SAS 6G Equalization Measurement proposal

Kees Propstra

Figure xxx Transmitter equalization measurement

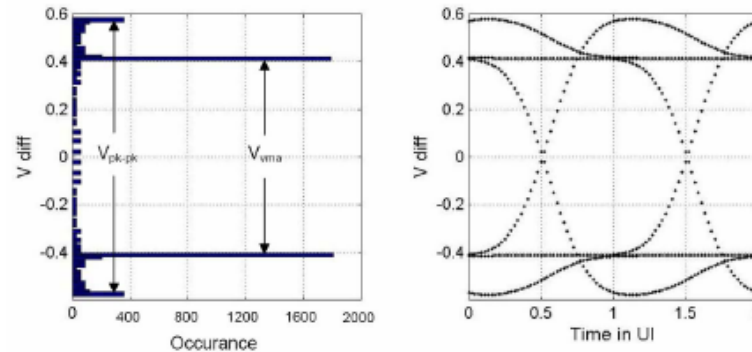
Limitations of current method

- Comparison of a peak to peak amplitude measurement with a mode amplitude measurement. V_{pk-pk} will include noise and V_{vma} will filter this out. As a consequence this method will not be truly representative of the equalization and will likely not correlate between different msmt devices.
- Whole UI is used to measure both V_{pk-pk} and V_{vma} . Different waveform shapes will yield different results. This does not help correlation.
- No association between transition and consecutive non-transition(s), as a result trends will skew the results.

Proposed new method - definition

Tx Equalization definition

Tx Equalization is the average ratio of the differential voltage amplitude of transitions bits versus the differential voltage amplitude of non-transitions bits. The differential voltage amplitudes are measured at the sample point (slicer) after clock recovery.

Tx Equalization measurement method

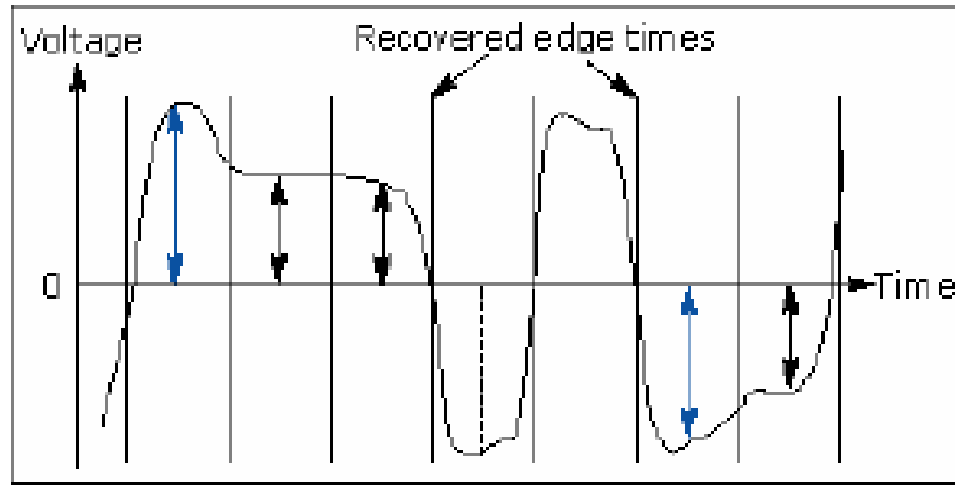
The Equalization measurement calculates the ratio of any non-transition eye voltage (2nd, 3rd, etc. eye voltage succeeding an edge) to its nearest preceding transition eye voltage (1st eye voltage succeeding an edge). The high and low voltages are measured in the center of the UI (after clock recovery).

Tx Equalization is the $20 \cdot \text{LOG}$ of the averaged voltage ratio.

- measurement performed after clock recovery (to determine location center UI)
- voltage level is determined at center of UI (by linear interpolation of two closest points)
- de-emphasis value is calculated for every non-transition bit
